The Northern Road Upgrade – Mersey Road, Bringelly to Glenmore Parkway, Glenmore Park

Submissions and Preferred Infrastructure Report Volume 1: Main Report

Roads and Maritime Services | December, 2017

Figure 5.3 | Directly affected businesses not shown in the EIS

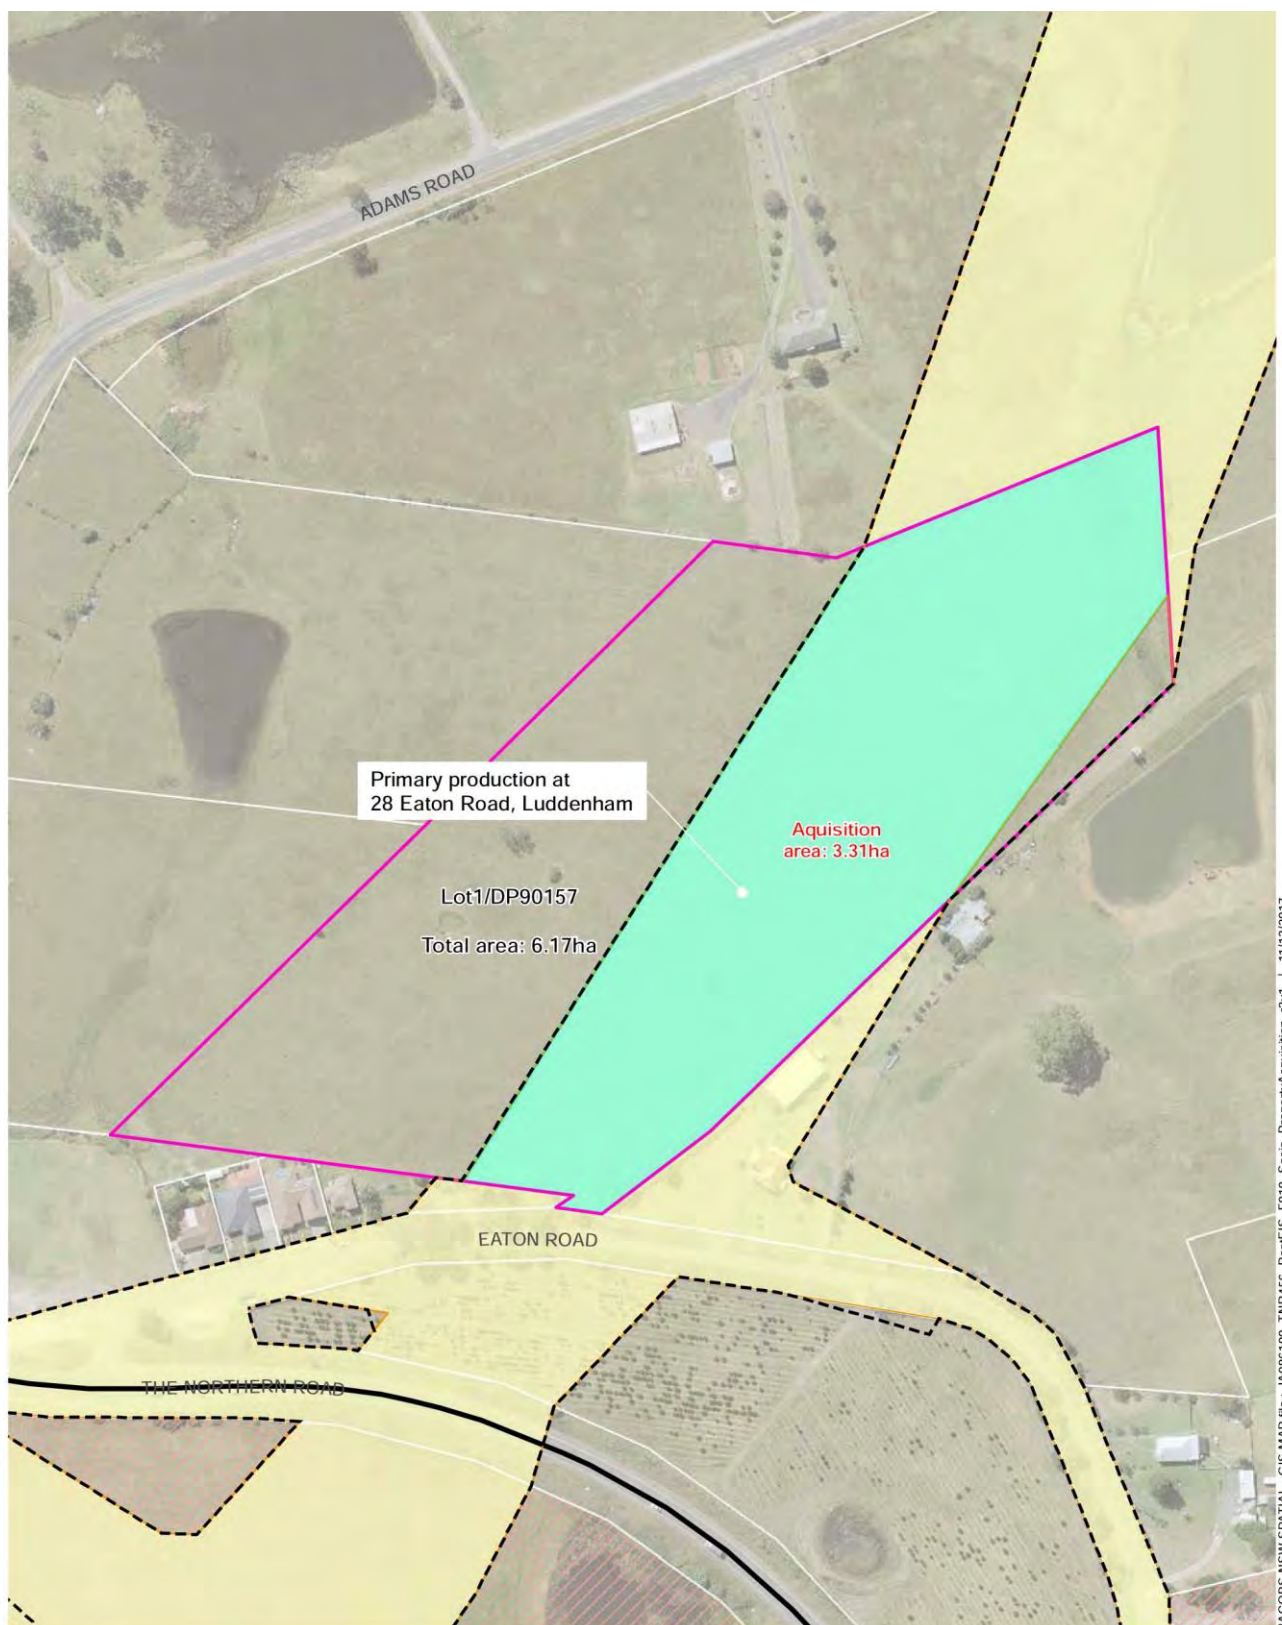
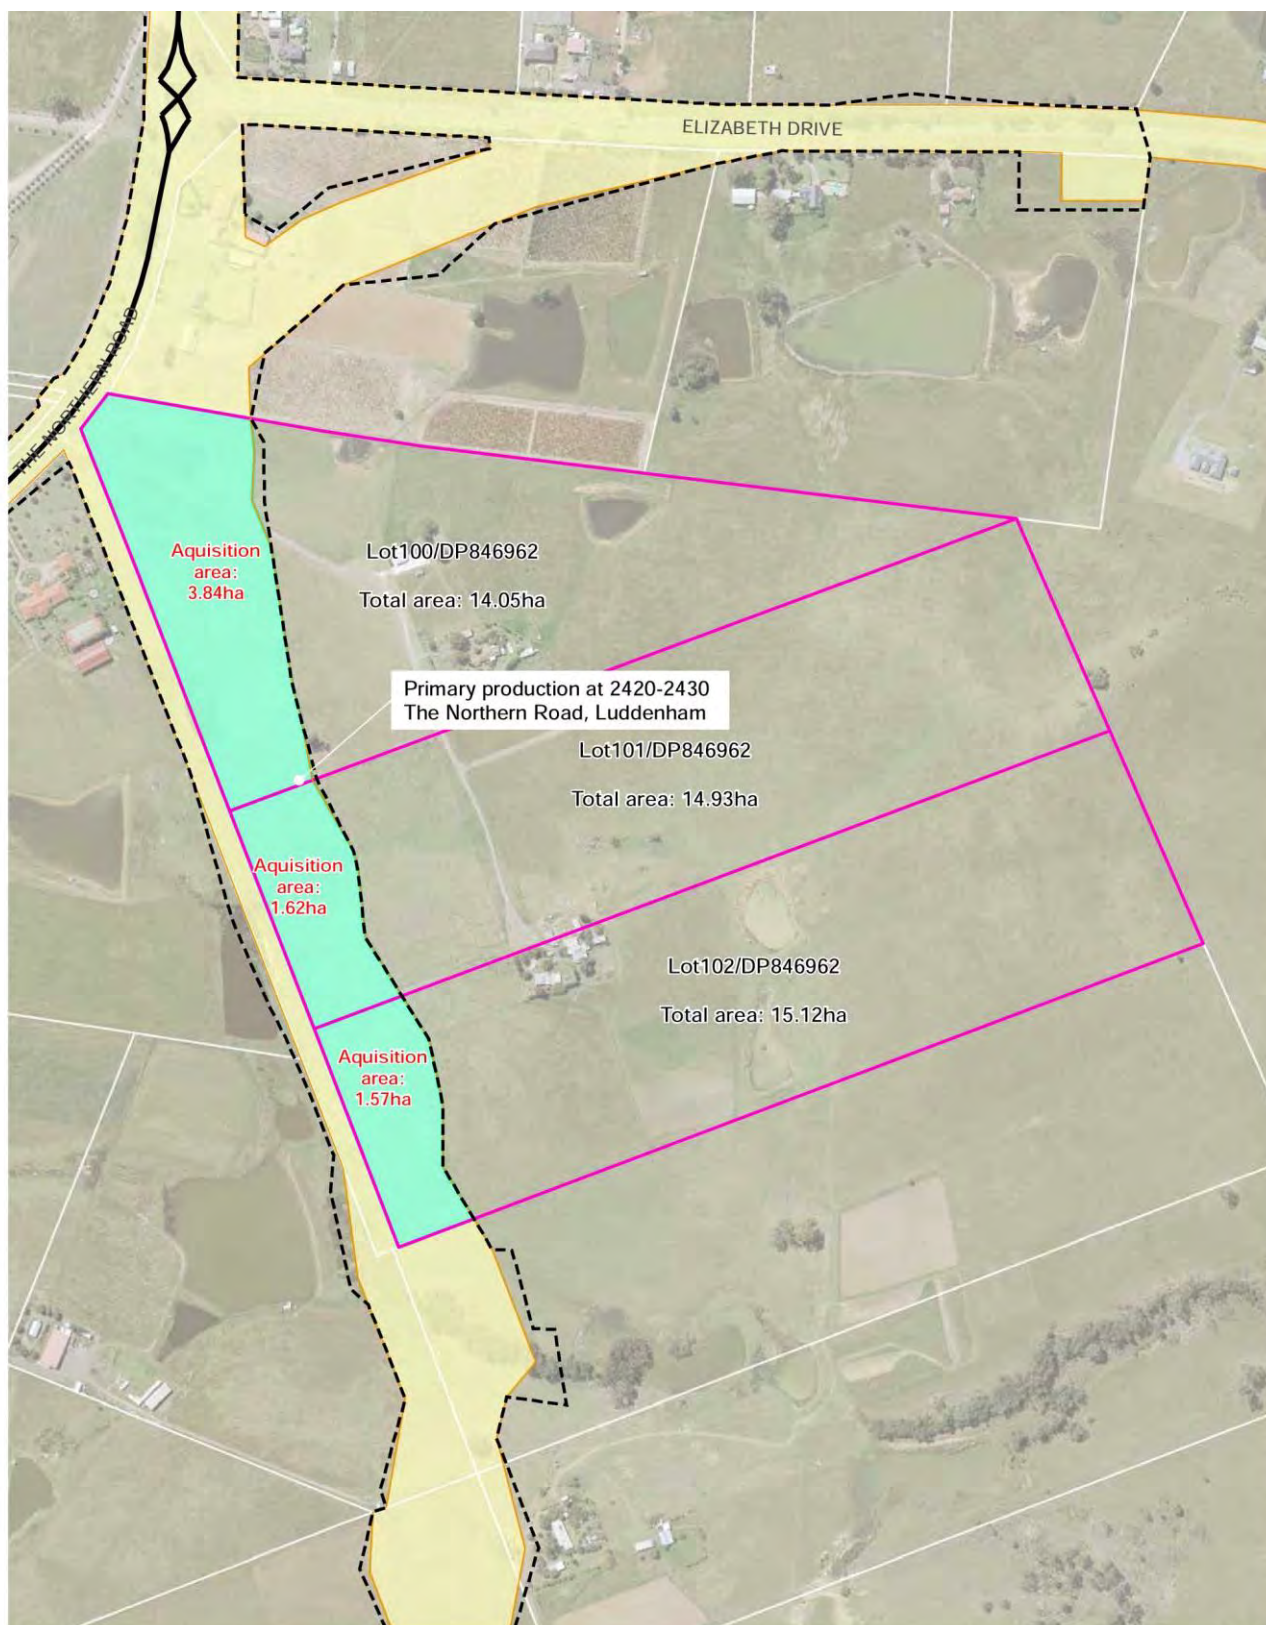
An error was identified in the EIS in relation to Figures 7-13 and 7-14 of the EIS which show the location of directly affected businesses and agricultural businesses respectively. These figures correspond to Table 7-62 of the EIS which summarises the potential impacts to businesses. It has been identified that some of the impacted primary production lots identified in this table of the EIS were not included in the corresponding figures as follows:

These additional properties are shown in Figure 5-3.

Figure 5-4 | Water quality controls

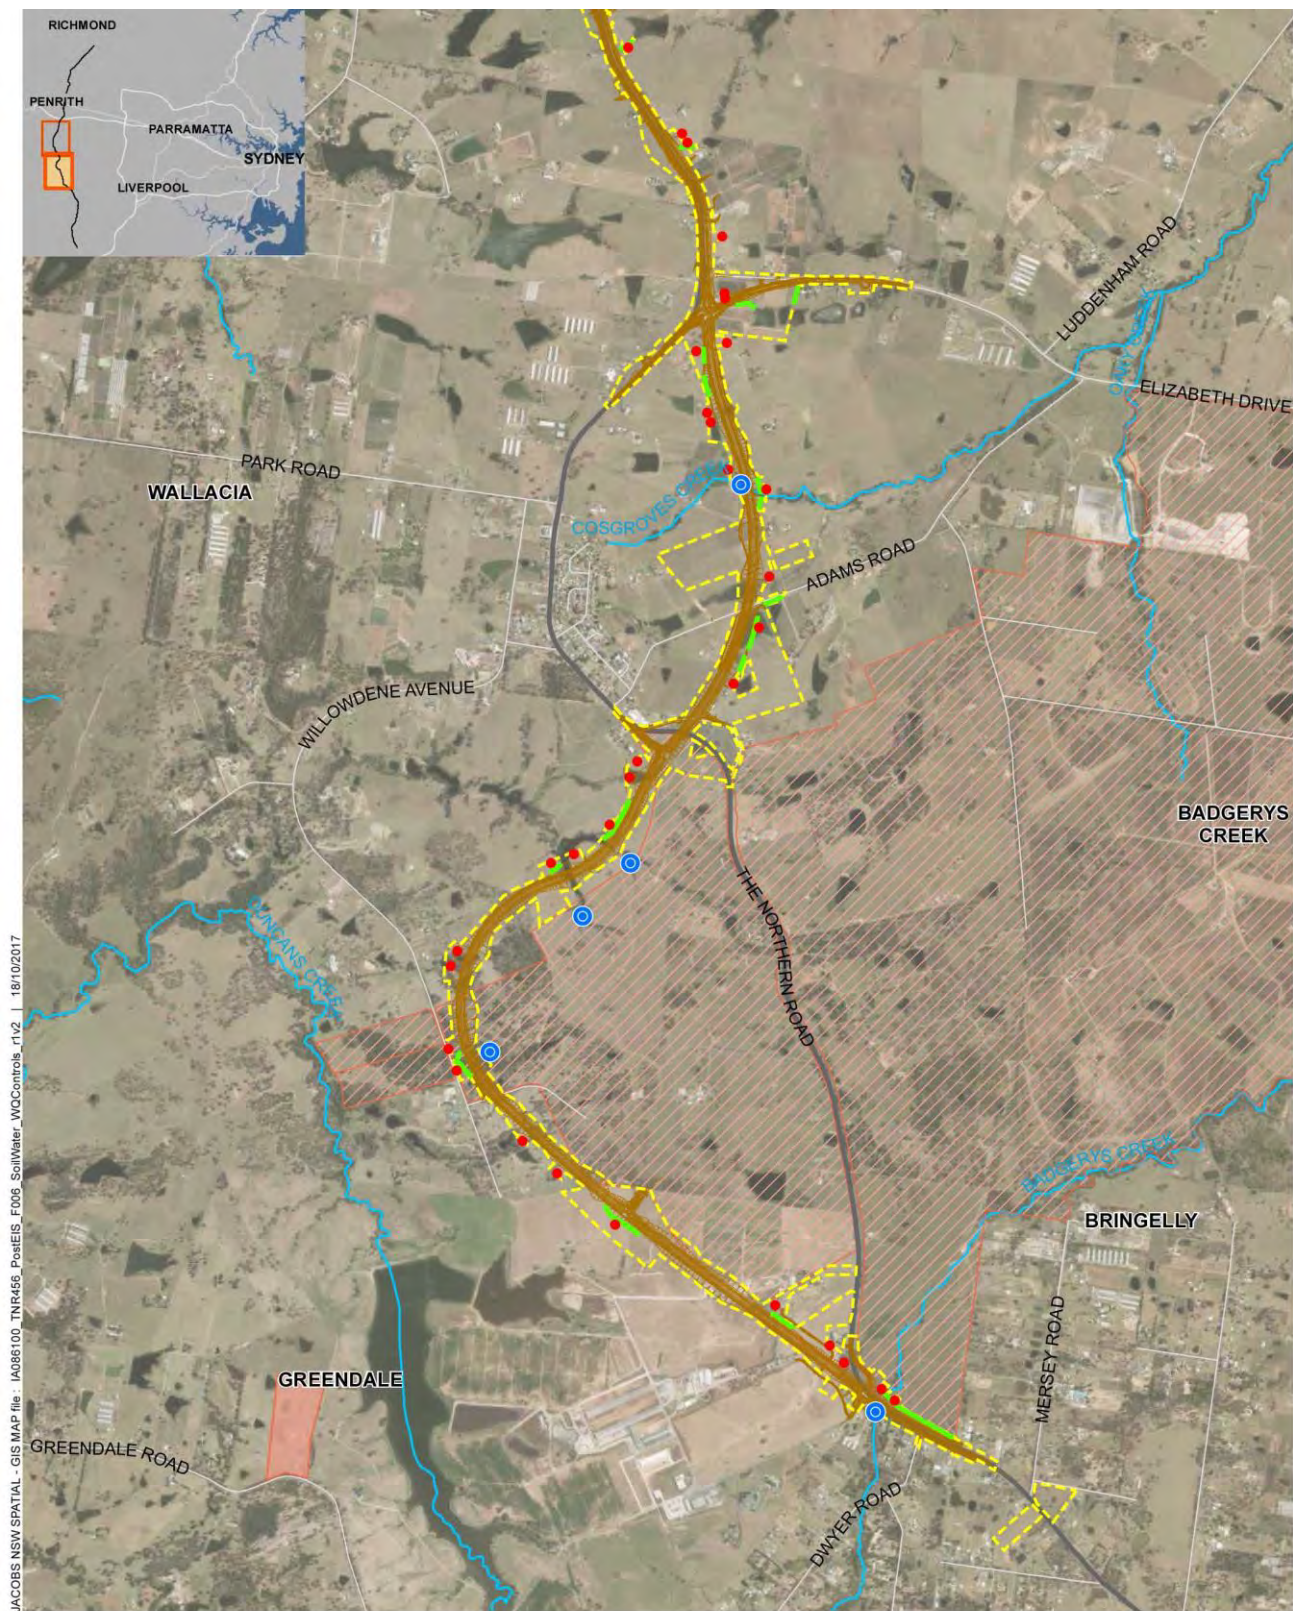
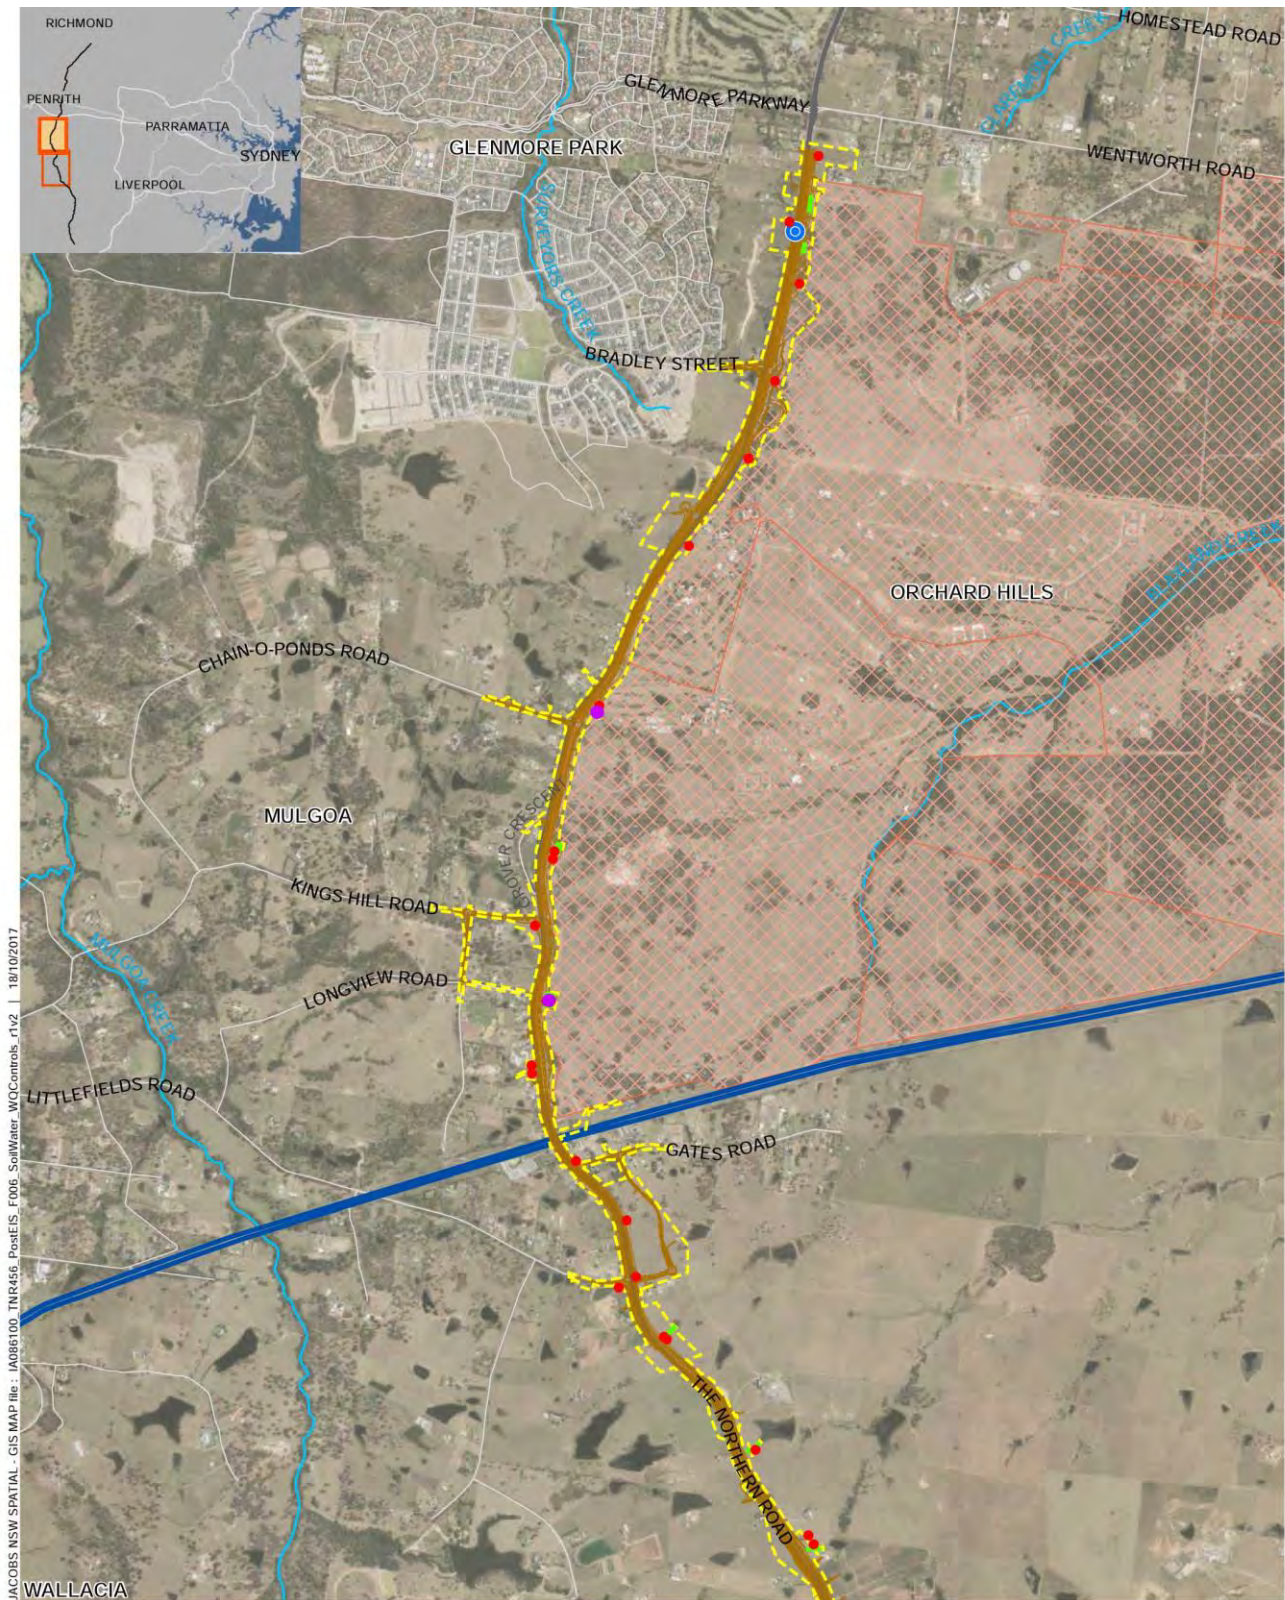
The EIS notes aquatic habitat assessments were undertaken over two days in February 2016 but due to the limited water availability and limited aquatic habitat macroinvertebrate surveys were deemed unnecessary (section 7.3.1, page 232). Figure 4.3 in Appendix I indicates aquatic surveys were undertaken at 5 sites and 4 of these were farm dams. The proponent should clarify why macroinvertebrate survey monitoring is not proposed along the tributaries of Blaxland Creek on the Orchard Hills Defence Establishment lands (Commonwealth land) and Badgerys Creek and Cosgroves Creek, particularly as the EIS notes that:

These monitoring locations have been incorporated into Figure 5-4 of this report.

Five waterway crossings in the study area, including the revised footprint, have been identified as Type 1 – Key Fish Habitats (DPI 2013), as they contain a combination of native aquatic plants and/or woody snags. These watercourses are impacted, intermittently flowing waterways which are also identified as Class 2 – Moderate Key Fish Habitat (Fairfull and Witheridge, 2003) due to the presence of limited in stream aquatic vegetation. Key fish habitats are shown on Figure 5-4 of this report for reference.
